Product Change Notice (PCN)

PCN Number: **PCN-0450881R-01**

Product(s) Affected: **PJ1-022**

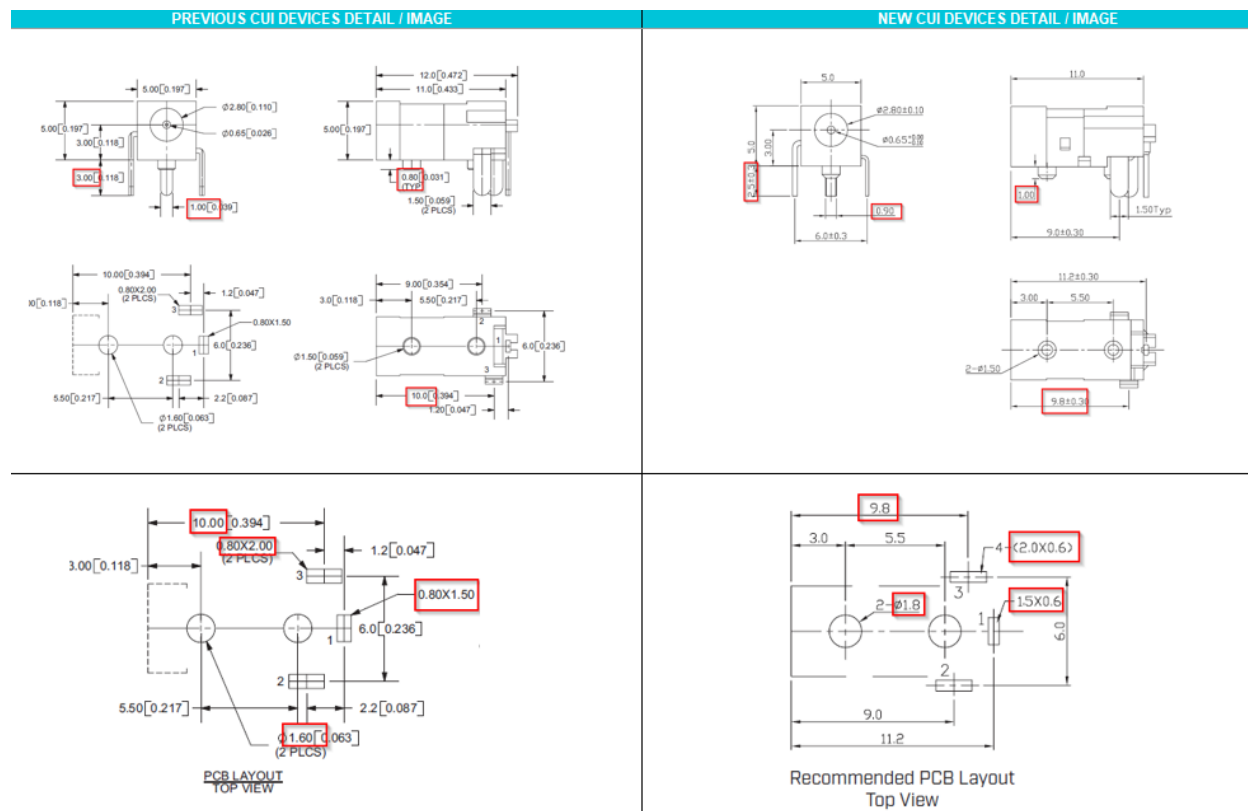
Description of Change: **Minor Housing and footprint differences. Material Change on the housing and terminals. See image Below**

PREVIOUS CUI DEVICES DETAIL / IMAGE			NEW CUI DEVICES DETAIL / IMAGE		
	MATERIAL	PLATING		MATERIAL	PLATING/COLOR
center pin	brass	silver	center pin	brass	silver
terminal 1	brass	silver	terminal 1	brass	silver
terminal 2	copper alloy	silver	terminal 2	Be-Cu t=0.25	silver
terminal 3	brass	silver	terminal 3	brass t=0.40	silver
plastic	PA66		housing	PA66 (UL94V-0)	black
